ENGINEERING CHANGE NOTICE **DART AEROSPACE LTD**

Reason for Change:
Add D212-722-013 Dzus Rail Brace Kit

DART SERVICE INSTRUCTION

TO AMEND INSTALLATION INSTRUCTIONS IIN-D212-722 REV. A

FIGURE 1: D212-722-013 DZUS RAIL BRACE INSTALLATION

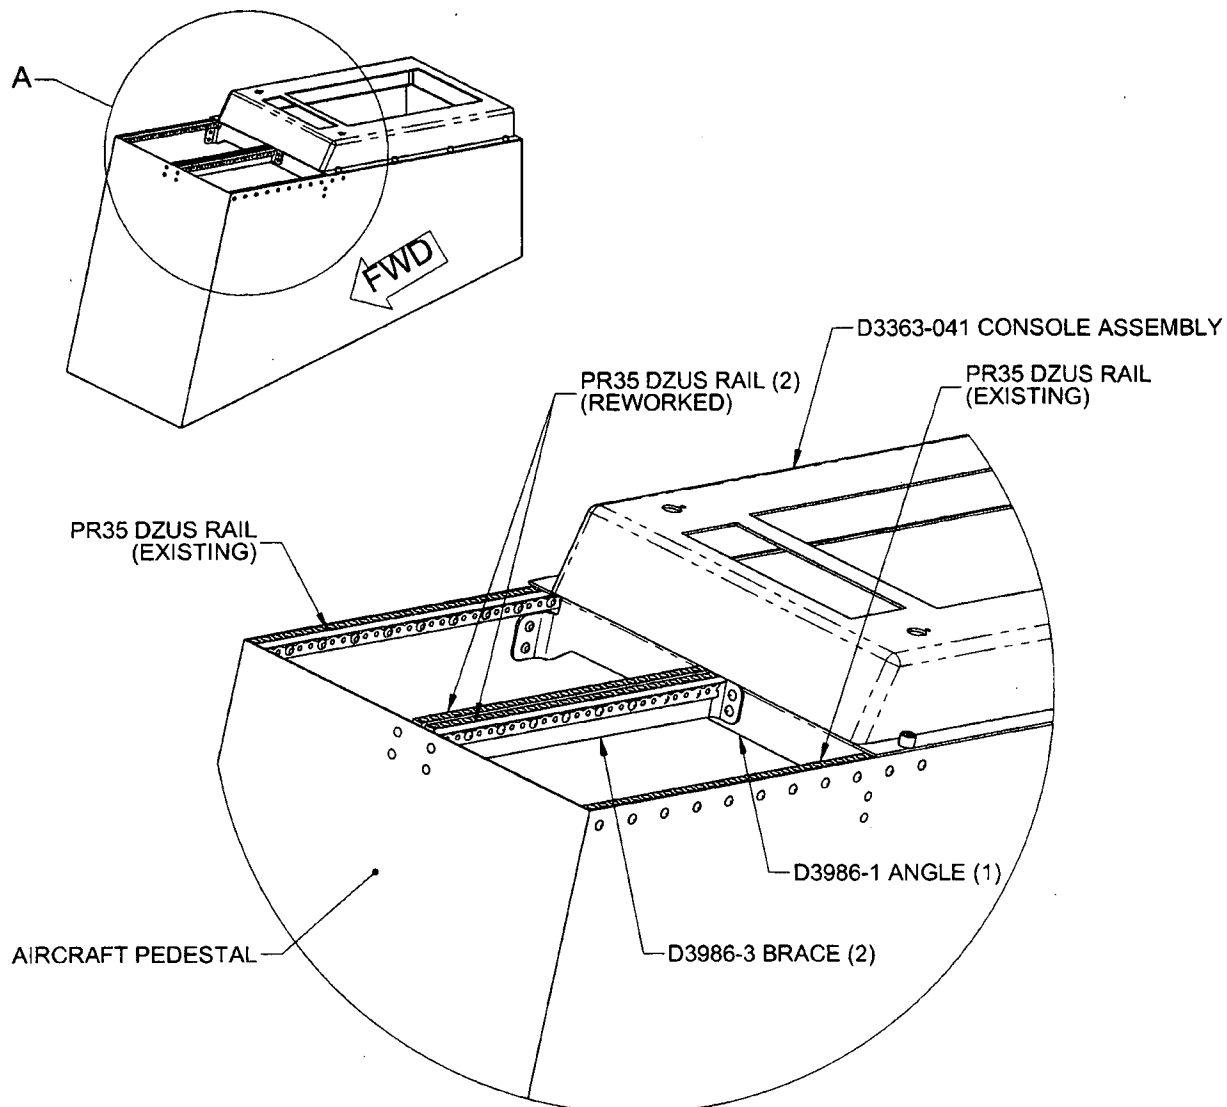
- 1) Remove the rivets securing the existing center PR35 dzus rails.
- 2) Remove the existing center dzus rail braces.
- 3) Clamp the D3986-1 angle, D3986-3 braces and PR35 dzus rail together as shown in Figure 1 (Sheet 3). The D3986-3 braces should be approximately centered between the existing dzus rails.

FIGURE 2: D212-722-013 DZUS RAIL BRACE INSTALLATION - OPTION 1
(PEDESTAL REMOVED FROM AIRCRAFT)

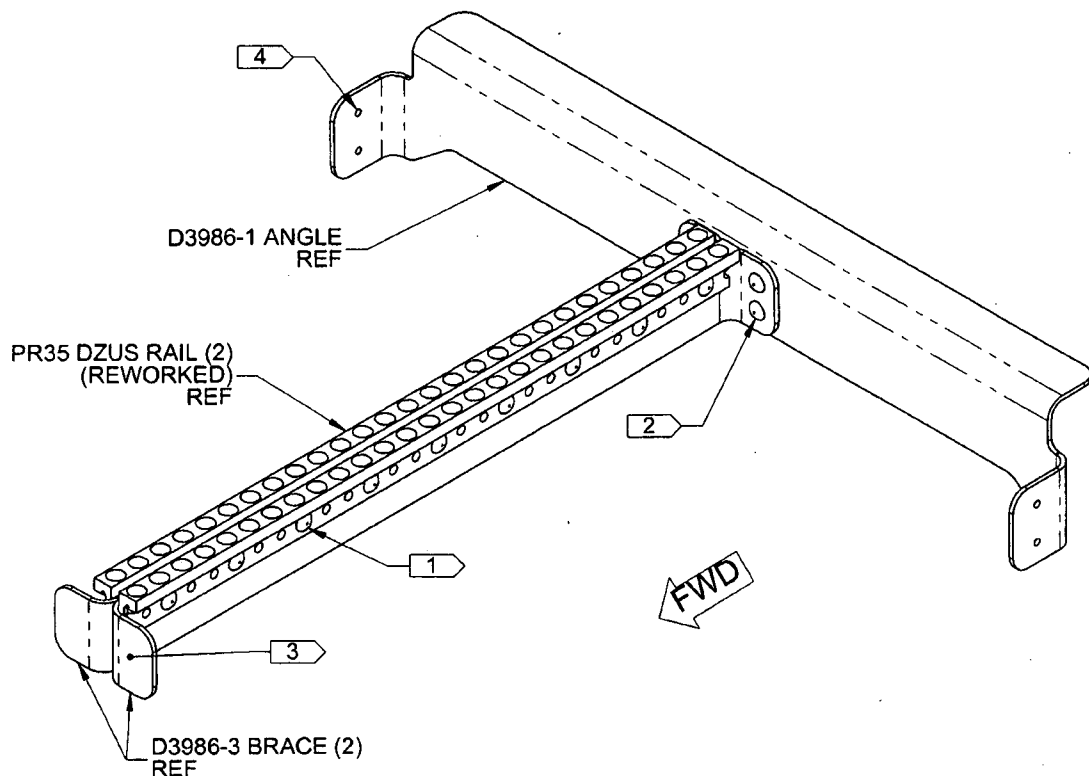
- 4) Install blanking plates (Figure 5, Sheet 7) to position the PR35 dzus rails in the correct position.
- 5) Transfer drill 9x $\varnothing 0.129$ (#30 drill) holes from PR35 dzus rail thru D3986-3 braces. See Figure 2, (Sheet 4), Note 1.

- 6) Deburr holes and reassemble using clecos.
- 7) Transfer drill 4x $\varnothing 0.129$ (#30 drill) holes from D3986-3 braces to D3986-1 angle. See Figure 2, (Sheet 4), Note 2.

- 8) Deburr holes and reassemble using clecos.
- 9) Transfer drill 4x $\varnothing 0.129$ (#30 drill) holes from aircraft pedestal to D3986-3 braces. See Figure 2, (Sheet 4), Note 3.

- 10) Deburr holes, dimple D3986-3 brace and aircraft pedestal and reassemble using clecos.
- 11) Transfer drill 4x $\varnothing 0.129$ (#30 drill) holes from D3986-1 angle to aircraft pedestal. See Figure 2, (Sheet 4), Note 4.

- 14) Install MS20470AD4 and MS20426AD4 rivets as shown in Figure 2 (Sheet 4) in the same order as the holes were drilled, maintaining the PR35 dzus rail position.

- 1) CONFIRM THAT DZUS RAIL AND BRACE ARE IN CORRECT POSITION AND TRANSFER DRILL $\varnothing 0.129$ (#30 DRILL) FROM PR35 DZUS RAIL THRU D3986-3 BRACES. INSTALL MS20470AD4 RIVETS, 9 PL TYP
- 2) CONFIRM THAT DZUS RAIL AND BRACE ARE IN CORRECT POSITION AND TRANSFER DRILL 4X $\varnothing 0.129$ (#30 DRILL) HOLES FROM D3986-3 BRACE TO D3986-1 ANGLE. INSTALL MS20470AD4 RIVETS, 4 PL
- 3) CONFIRM THAT DZUS RAIL AND BRACE ARE IN CORRECT POSITION AND TRANSFER DRILL 4X $\varnothing 0.129$ (#30 DRILL) FROM AIRCRAFT CONSOLE TO D3986-3 BRACES. DIMPLE D3986-3 BRACES AND INSTALL MS20426AD4 RIVETS, 4 PL.
- 4) CONFIRM THAT DZUS RAIL AND BRACE ARE IN CORRECT POSITION AND TRANSFER DRILL 4X $\varnothing 0.129$ (#30 DRILL) FROM D3986-1 ANGLE TO AIRCRAFT CONSOLE. DIMPLE D3986-1 ANGLE AND AIRCRAFT CONSOLE AND INSTALL MS20426AD4 RIVETS, 4 PL

FIGURE 3: D212-722-013 DZUS RAIL BRACE INSTALLATION - OPTION 2
(PEDESTAL NOT REMOVED FROM AIRCRAFT)

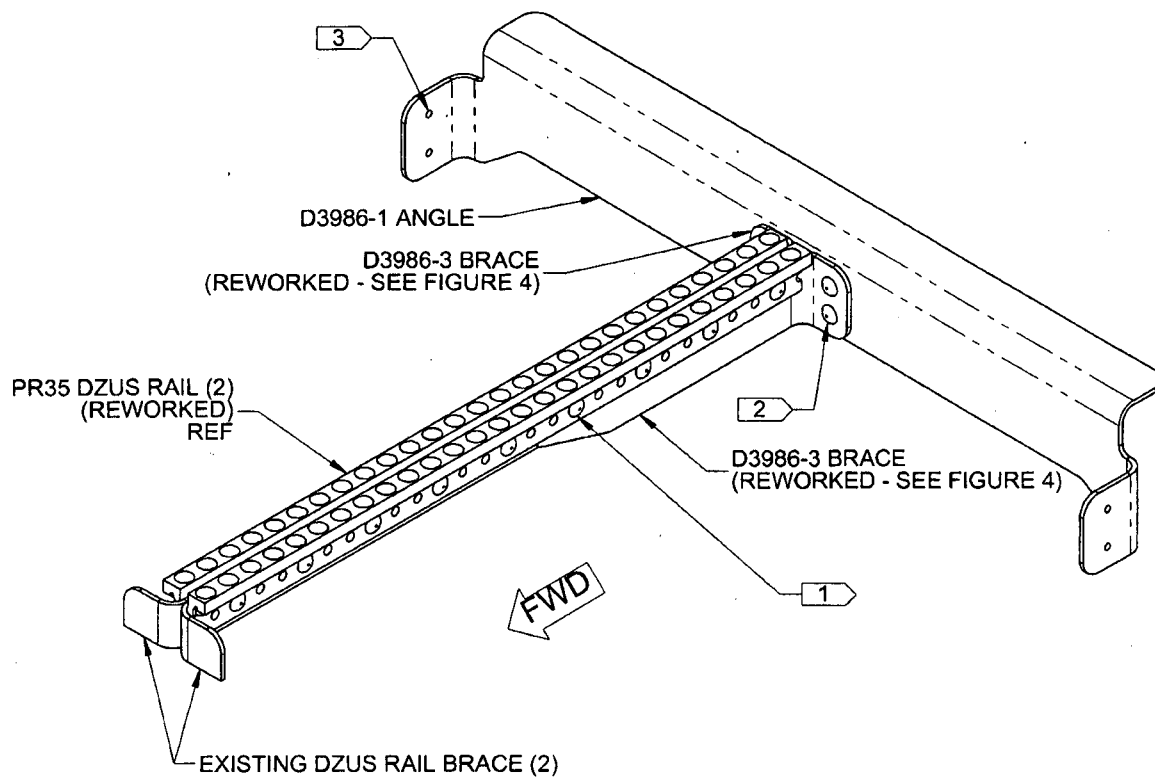
- 3) Trim D3986-3 braces so that when matched with the existing dzus rail braces the original D3986-3 length is maintained.
- 4) Clamp and cleco the D3986-1 angle, the trimmed D3986-3 braces and PR35 dzus rail together as shown in Figure 3 (Sheet 5).

- 5) Install blanking plates (Figure 5, Sheet 7) to position the PR35 dzus rails in the correct position.
- 6) Transfer drill $\varnothing 0.129$ (#30 drill) the necessary holes (4 typ) from PR35 dzus rail thru D3986-3 braces. See Figure 3, (Sheet 5), Note 1.

- 7) Deburr holes and reassemble using clecos.
- 8) Transfer drill 4x $\varnothing 0.129$ (#30 drill) holes from D3986-3 braces to D3986-1 angle. See Figure 3, (Sheet 5), Note 2.

- 9) Deburr holes and reassemble using clecos.
- 10) Transfer drill 4x $\varnothing 0.129$ (#30 drill) holes from D3986-1 angle to aircraft console. See Figure 3, (Sheet 5), Note 3.

- 13) Install MS20470AD4 and MS20426AD4 rivets as shown in Figure 3 (Sheet 5) in the same order as the holes were drilled, maintaining the PR35 dzus rail position.

- 1) CONFIRM THAT DZUS RAIL AND BRACE ARE IN CORRECT POSITION AND TRANSFER DRILL (4 PL TYP) $\varnothing 0.129$ (#30 DRILL) FROM PR35 DZUS RAIL THRU D3986-3 BRACES. INSTALL MS20470AD4 RIVETS, 9 PL TYP
- 2) CONFIRM THAT DZUS RAIL AND BRACE ARE IN CORRECT POSITION AND TRANSFER DRILL 4X $\varnothing 0.129$ (#30 DRILL) HOLES FROM D3986-3 BRACE TO D3986-1 ANGLE. INSTALL MS20470AD4 RIVETS, 4 PL
- 3) CONFIRM THAT DZUS RAIL AND BRACE ARE IN CORRECT POSITION AND TRANSFER DRILL 4X $\varnothing 0.129$ (#30 DRILL) FROM D3986-1 ANGLE TO AIRCRAFT CONSOLE. DIMPLE D3986-1 ANGLE AND AIRCRAFT CONSOLE AND INSTALL MS20426AD4 RIVETS, 4 PL

FIGURE 4: EXISTING DZUS RAIL BRACE TRIMMING DETAIL - OPTION 2
(REWORKED DZUS RAILS AND RIVETS NOT SHOWN FOR CLARITY)

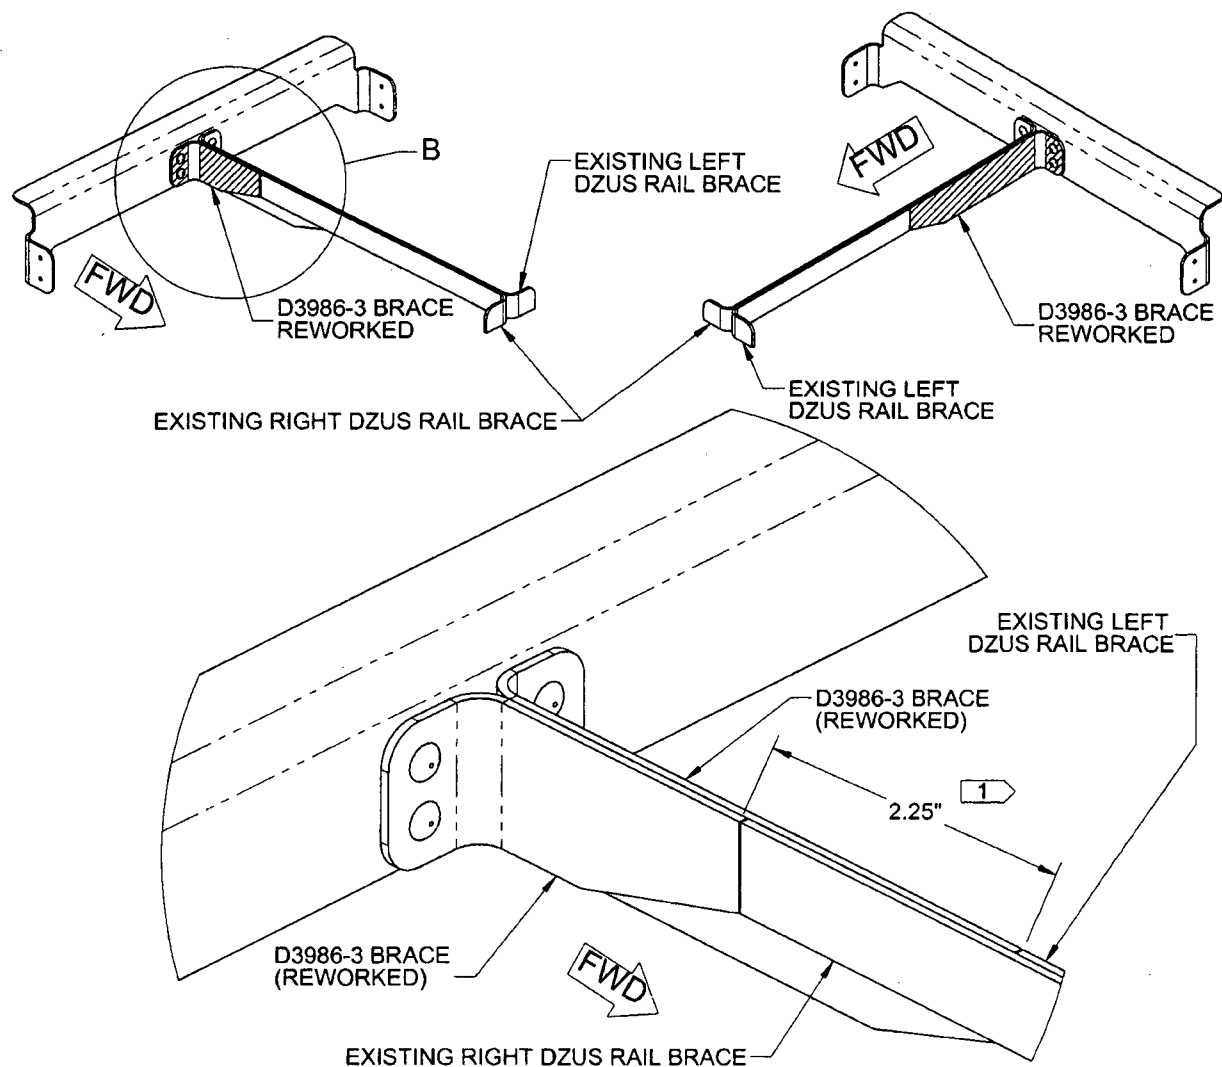
- 1) Remove the rivets securing the PR35 center dzus rails from the existing dzus rail brace. Remove dzus rail.
- 2) Without removing it, trim the existing left dzus rail brace, as shown in Figure 4 (Sheet 6). Trim the existing right dzus rail brace 2.25" longer. See Note 1 Figure 4 (Sheet 6).

- 1) TRIM EXISTING LEFT DZUS RAIL BRACE SO THAT THE END IS HALF WAY BETWEEN EXISTING RIVET HOLES. TRIM EXISTING RIGHT DZUS RAIL BRACE 2.25" LONGER

FIGURE 5: BLANKING PLATE

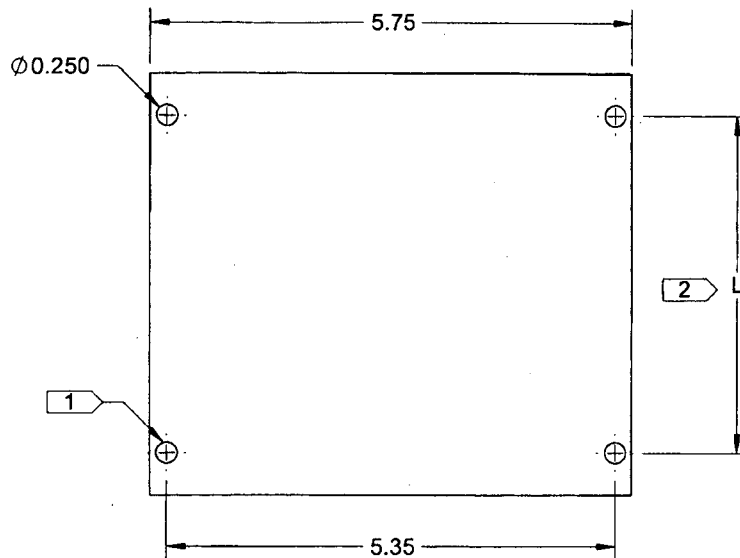
- 12) Deburr holes, dimple D3986-1 angle and aircraft pedestal and reassemble using clecos.
- 13) Re-install blanking plates (Figure 5, Sheet 7) and verify correct position of PR35 dzus rails.

- 1) INSTALL DZUS FASTENERS, 4 PL TYP
- 2) DIMENSION "L" IS MIN 4". MUST BE DIVISIBLE BY 0.375
